RE: Annual Inspection for Parcel N North Ridge Estates Superfund Site ECSI No. 6000

Operations and Maintenance Inspection Form

U				
	50	0)	25	50			
		(FE	ET)					
	Lot N Inspection 2023 Annual Inspection Summary Report North Ridge Estates - Operable Unit 1 Klamath Falls, Oregon							
	Apex Companies, LLC 15618 SW 72nd Avenue APEX Tigard, Oregon 97224	Project Number: 32-23006007 Augus	JP	MS/AB	Figure

Ground Disturbing Activities

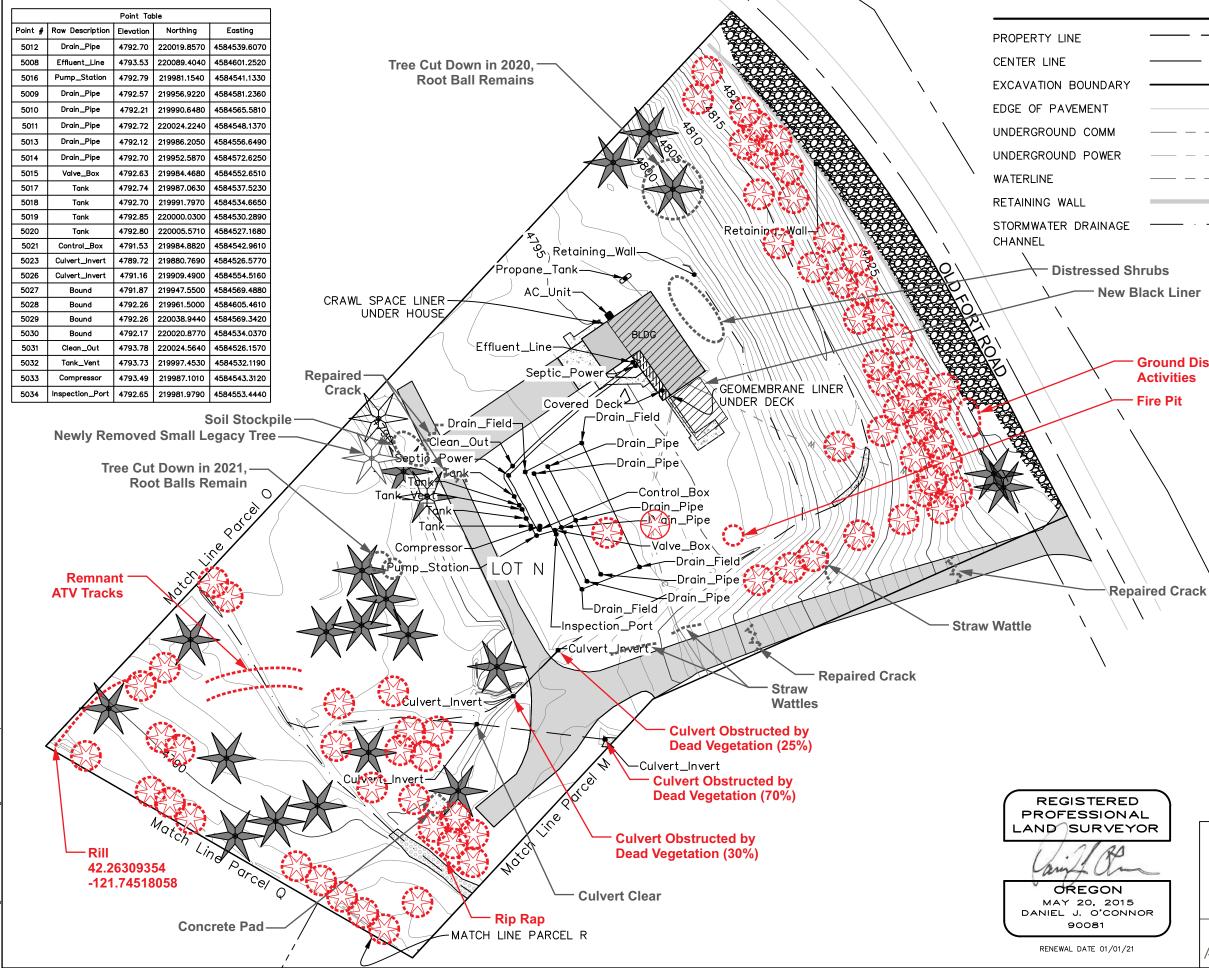
Have vehicles damaged the protective cap?		X			Ground dis	turbance observed near northwest corner	of parcel adjoining Old Fort Road; ATV	/ tracks observed throughout parcel.	
	Any evidence of ACM on Site including areas where the protective cap is less than 2 feet (see as-built drawings) or within the dripline of the legacy trees?			⊠						
	Are there areas that show evidence of unstable slopes, subsidence, or slope failure? Are there signs of active bank erosion and/or lateral cutting?			Ø						
	Any visible ACM along the perimeter of the Site (where applicable)?			⊠						
Vegetation	Evidence of distressed or sparse vegetation? (sparse vegetation no greater than 10 percent of area and bare areas no greater than 100 square feet)			×						
	Evidence of trees and shrubs in distress?		×			Shrubs on northea		ess. A dead "new" tree was identified o ees observed to be in healthy condition	n southern corner of parcel. (Same as 2022) n.

Obstructions observed in ditches or culverts that may impede conveyance of stormwater?	×			Culverts observed to be partially obstructed along southern driveway. (Same as 2022)	Remove obstructions from culverts to enable stormwater flow.
Ditches and Culverts						
	Damaged observed to riprap surface? Note if riprap is not intact or not effectively providing armor protection.		X			
	Are there any areas that show signs of excessive scour? (i.e., gullies forming along centerline of ditch)		X			
	Are culvert inlets and outlets damaged?		X			
Driveways and Walkways	Are the driveways showing signs of failure? (i.e., alligator cracking)		X		Cracks in the asphalt driveway have been repaired since 2021 inspection.	
	Are there any other signs of considerable damage to paved surfaces, other than normal wear and use?					
Crawlspaces and Decks	Are the liners inside crawlspaces and under covered decks damaged or punctured?				Geomembrane visible at the southern corner of the deck.

Are the liners exposed to UV radiation?		X			
Access Controls	Are access controls damaged?			Ø		
	Are changes to the access controls needed?			Ø		
Miscellaneous Features / Changes in Site Conditions / Misc.	Are there any new site features installed that have damaged the protective cap?		X		Subsurface irrigation lines were exposed on the south corner of the parcel.

Corrective Action. Remove the material obstructing the culverts to allow the unrestricted flow of stormwater by November 12, 2023.
